NUCLEAR REGULATORY COMMISSION

Application of SOUTHERN CALIFORNIA)	Docket No. 50-361
EDISON COMPANY, <u>ET AL.</u> for a Class 103)	
License to Acquire, Possess, and Use)	
a Utilization Facility as Part of)	Amendment Application
Unit 2 of the San Onofre Nuclear)	No. 132
Generating Station)

DESCRIPTION AND SAFETY ANALYSIS
OF PROPOSED CHANGE NPF 10/15-427

This is a request to revise Technical Specification (TS) 3/4.8.1, "A. C. Sources," to allow a one-time exception for replacement of transformers B04X and B06X during the San Onofre Units 2 and 3 Cycle 7 refueling outages.

FIGURE 1

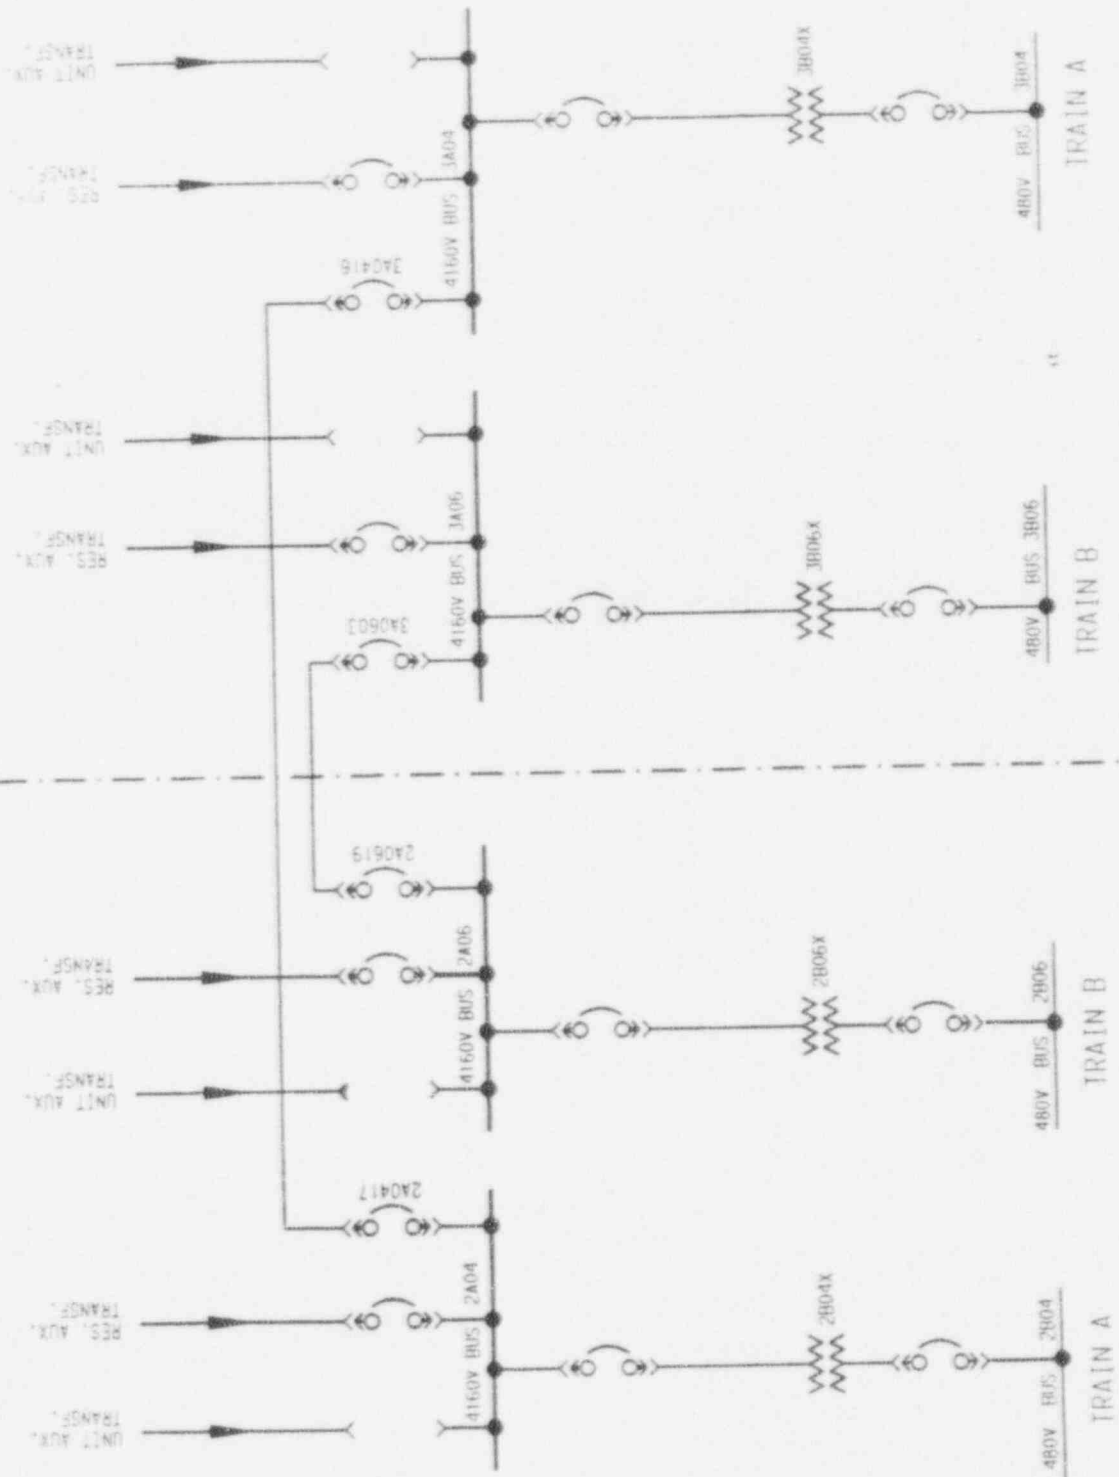
The cross-ties between the Units are at the 4kV level only. Transformers B04X and B06X are 4kV/480V and allow 480V loads to be connected to their own Unit's respective 4kV buses (2B04 to 2A04, 2B06 to 2A06, etc.).

During the upcoming Units 2 and 3 Cycle 7 refueling outages, SCE intends to replace the 480V load center transformers B04X and B06X. In accordance with SR 4.8.1.1.1.a, the Unit 2 load centers, including these transformers, are required to be OPERABLE for the Unit 3 cross-tie and vice versa. Therefore, during the Unit 2 Cycle 7 refueling outage, the replacement of load center transformers 2B04X and 2B06X will cause the cross-tie to Unit 3 to become INOPERABLE. The replacement work is expected to require approximately 120 hours per train to complete. TS 3.8.1.1 ACTION a.1 allows only 72 hours with one of the two A. C. sources unavailable before the unit must be shut down. Therefore, Unit 3 would also need to be shut down. This situation will be reversed during the Unit 3 Cycle 7 refueling outage.

This proposed change will add a footnote to SR 4.8.1.1.1.a for Units 2 and 3 to allow the tie breakers to remain OPERABLE with load centers B04 and B06 INOPERABLE because of the 480V transformer replacement during the opposite unit
